Re: Initial Submission Review: ENT Credit Union at Smoky Hill Crossing – Site Plan with Adjustment and Conditional Use
Application Number: DA-2184-06
Case Numbers: 2020-6024-00, 2020-6024-01

Initial Submission Review

Table 4.5-3

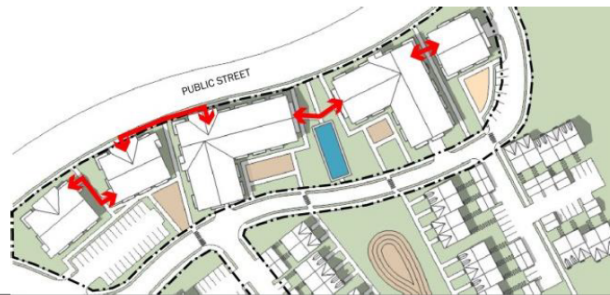
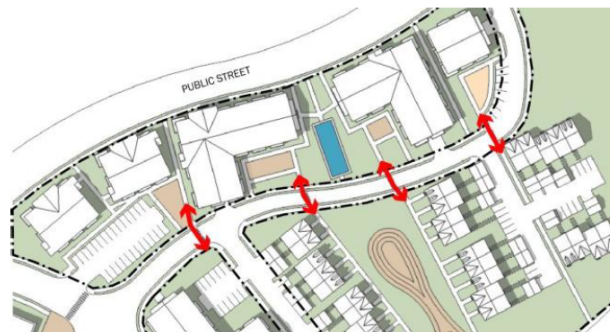
- 1.B.3.h Adjust the small typo in "crosswalk." **Response: Revised.**
- 1.B.3.i Provide a pedestrian route to the other pad sites within the development. Table 4.5-3 of the UDO requires connections as shown in the excerpt below. **Response: Pedestrian walkway has been added but not ada.**
